Water Right Conditions
Tracking Slip

FILE ## G-17498

PUBLIC INTEREST REVIEW FOR GROUND WATER APPLICATIONS

TO: Water Rights Section Date April 25, 2012
 FROM: Ground Water/Hydrology Section Michael Zwart
 SUBJECT: Application G- 17498 Reviewer's Name
 Supersedes review of _____ Date of Review(s)

Application G-17498, Arthur L. and Lillian E. Frease

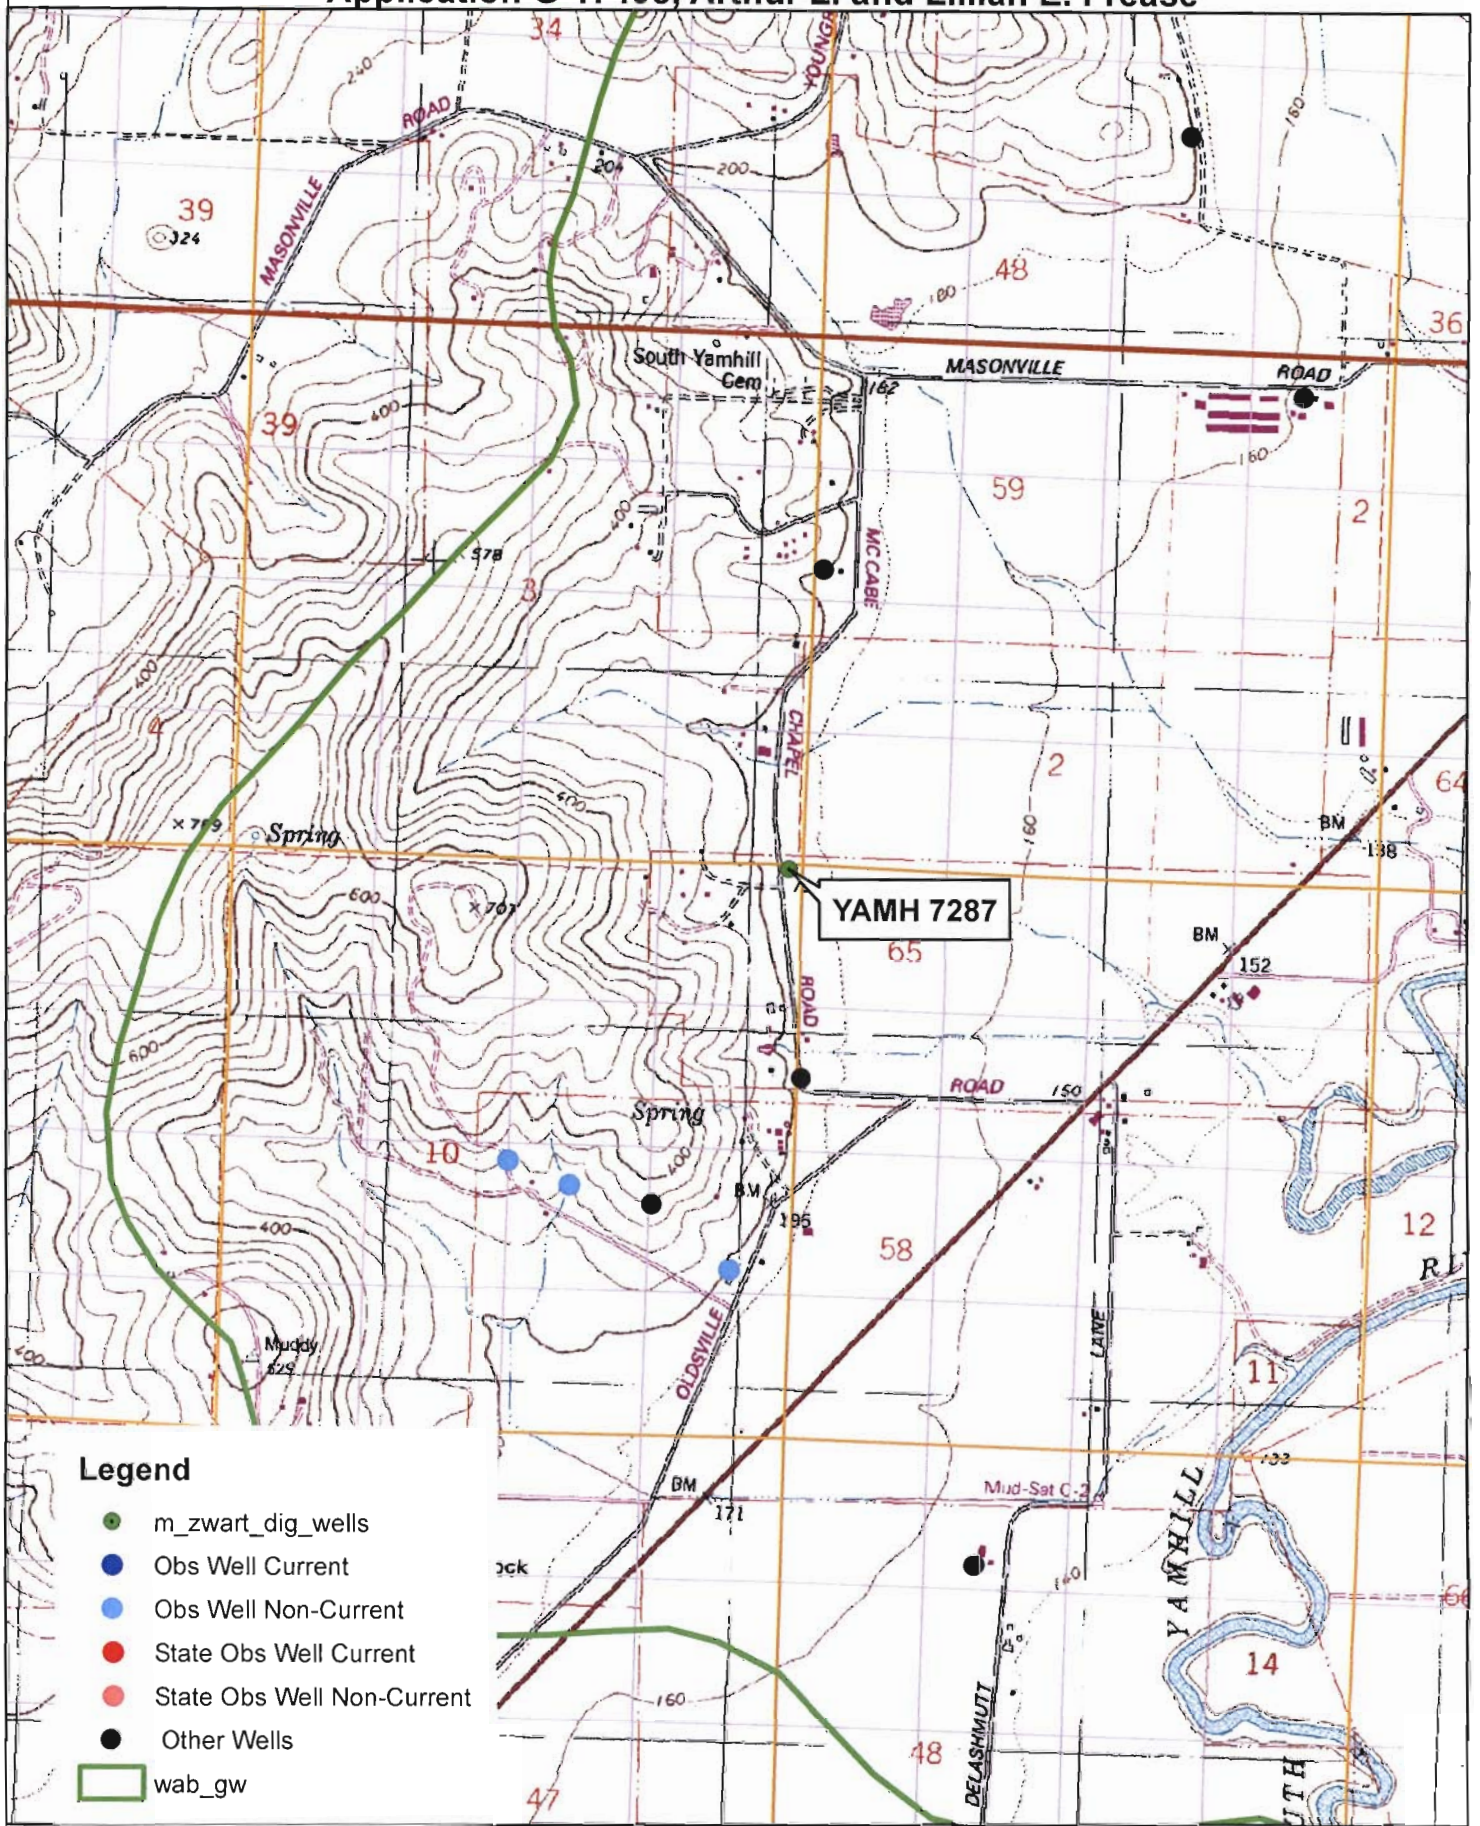
B3. Ground water availability remarks: The subject property lies at the break in slope between Coast Range foothills on the west and the floodplain of the South Yamhill River to the east. The foothills of the Coast Range are composed of marine sedimentary rocks (mapped locally as the Nestucca Formation) whereas the floodplain of the South Yamhill River is composed of younger alluvial and lacustrine sediments. The older marine sediments occur at depth beneath the floodplain sediments. Marine sedimentary rocks in the western Willamette Valley generally have low porosity and low permeability. Most of the available pore space is likely to occur in fractures. Groundwater generally appears to occur under confined conditions although unconfined conditions probably occur at very shallow depths near land surface. Groundwater is likely to flow from the highlands immediately to the west towards the South Yamhill River to the east. Water table maps published by the U.S. Geological Survey indicate that groundwater in the South Yamhill floodplain flows toward and discharges into the South Yamhill River. The proposed POA, YAMH 7287, produces water from marine sedimentary rocks which are encountered at 28 feet below land surface. The median well yield in sections 2 and 3 of T. 5S, R 5W is 12.5 gallons per minute based on records in the OWRD well log database. Our general experience indicates that drawdowns tend to increase and well yields tend to decrease over time in the marine sediment aquifer. No local groundwater-level data are available to assess the stability of water levels in the area. However, only a few scattered water rights have been issued in the area and domestic well density is very low. Therefore, groundwater levels are likely to be relatively stable (Wozniak, 2009 review of file G-17246).

Basis for aquifer confinement evaluation: The static water level is well above the depth where groundwater was first encountered. This is consistent with general knowledge of the low-yield marine bedrock aquifer

Basis for aquifer hydraulic connection evaluation: The reported water level on the well log is equivalent to a water-level elevation of 182 feet. This indicates flow towards the South Yamhill River. Water table maps indicate that groundwater flows toward and discharges to the South Yamhill River.
